THE NEW W. EDWARD BALMER SCHOOL

SCHOOL BUILDING COMMITTEE MEETING

APRIL 2, 2019

VE LIST: A04-ITEM 19

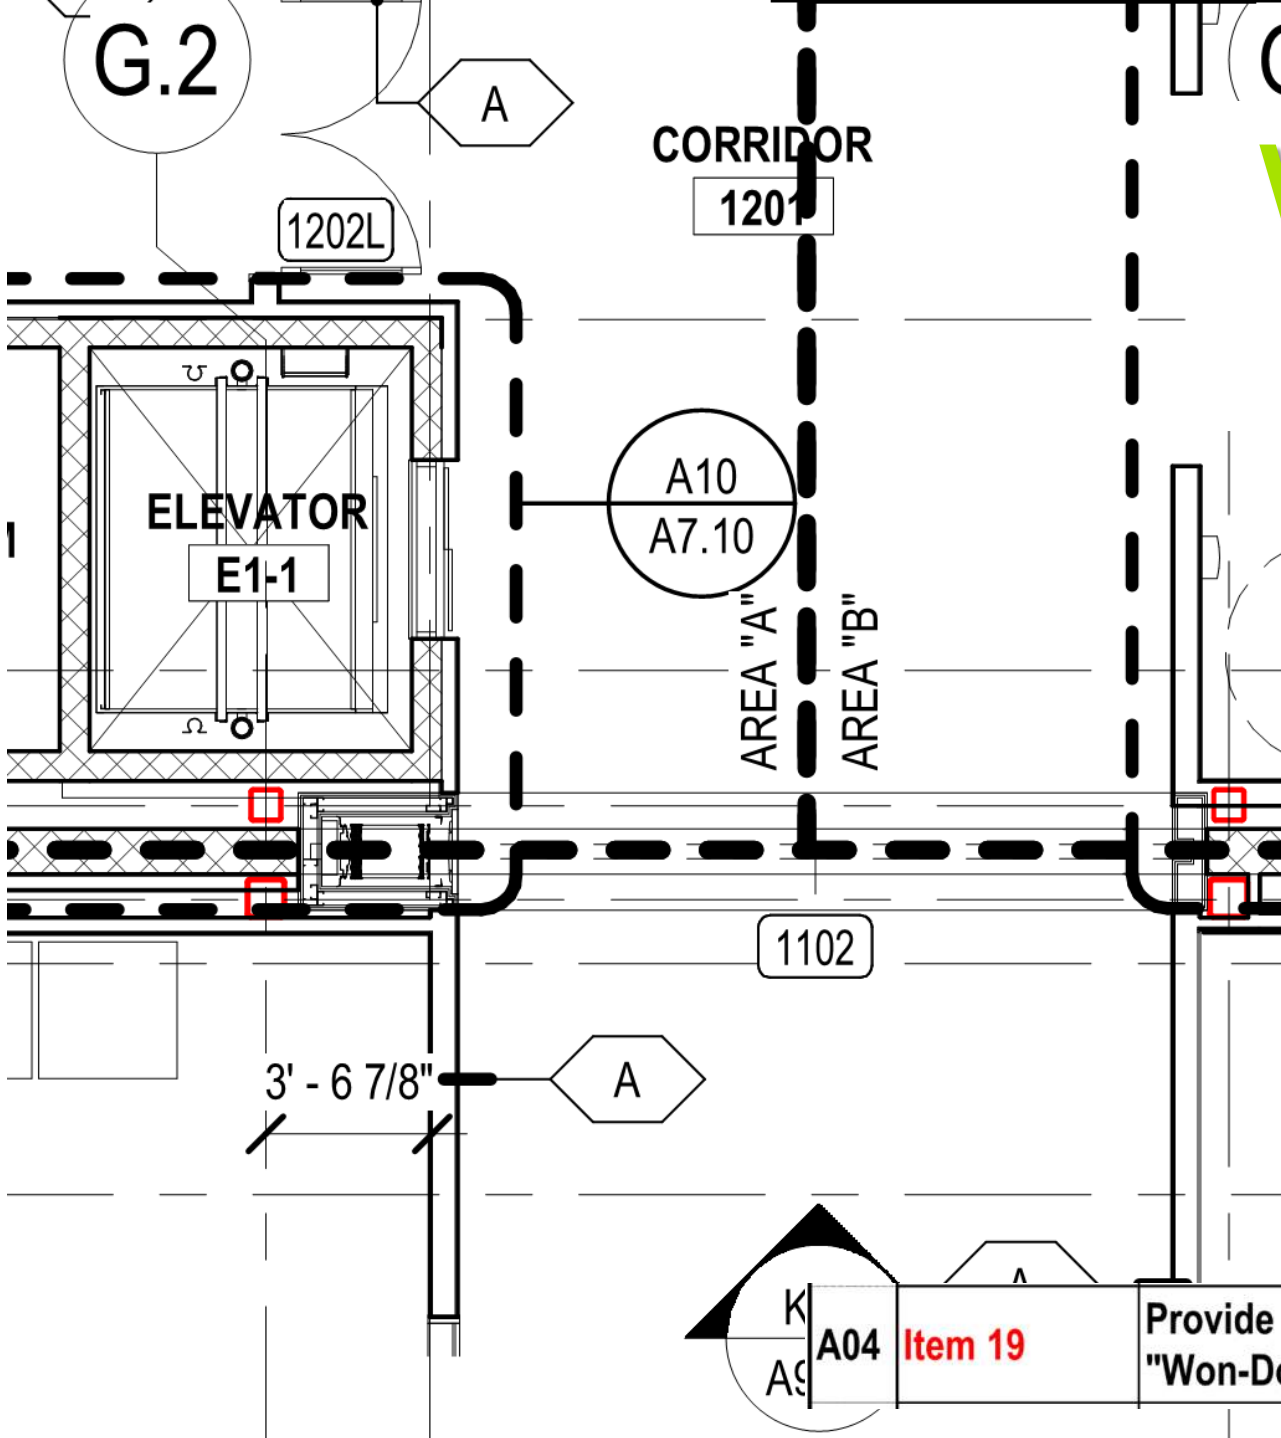
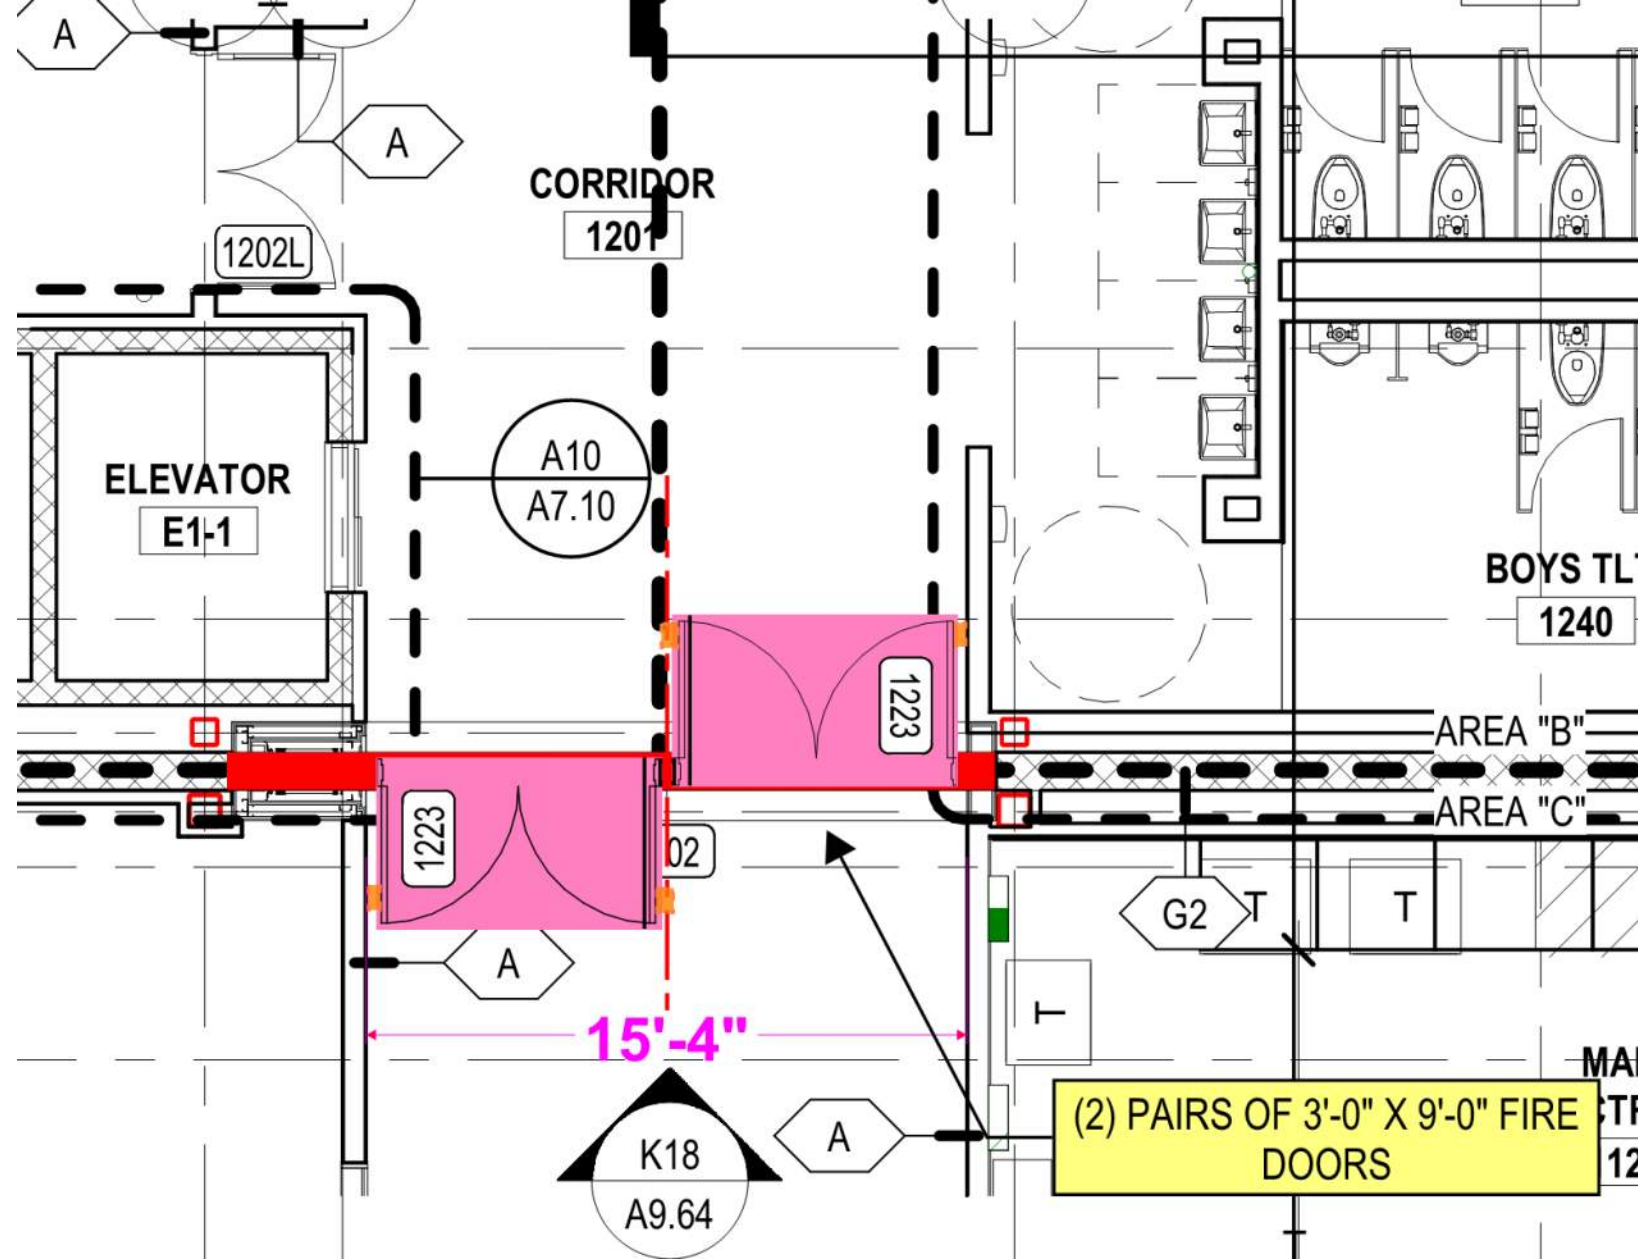
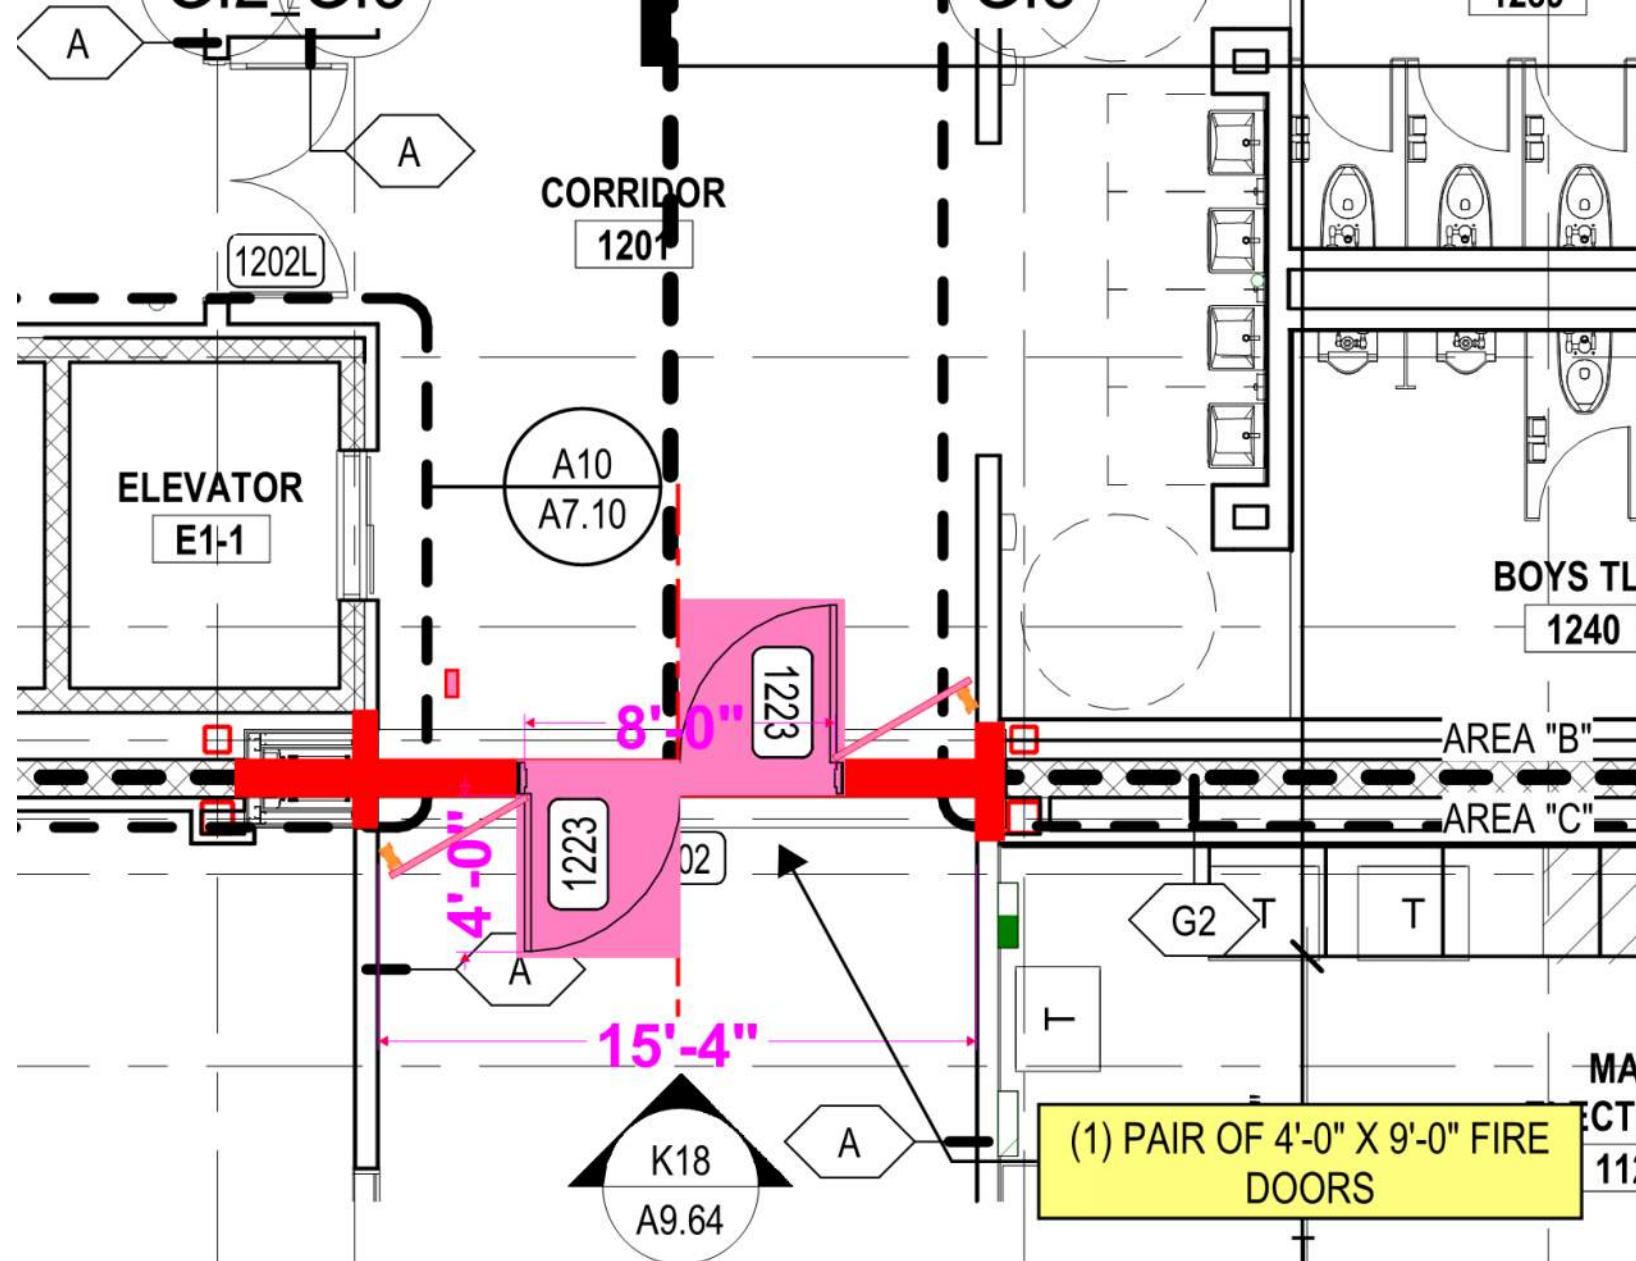
Provide swinging full-height fire doors [(2) pairs @ 4' w x 9' tall] ILO
"Won-Door" sliding fire door (3 levels)

(\$66,932)

A04	Item 19	Provide swinging full-height fire doors [(2) pairs @ 4' w x 9' tall] ILO "Won-Door" sliding fire door (3 levels)	(\$66,932)
-----	---------	--	------------

A04	Item 19	Provide swinging full-height fire doors [(2) pairs @ 4' w x 9' tall] ILO "Won-Door" sliding fire door (3 levels)	(\$66,932)
-----	---------	--	------------
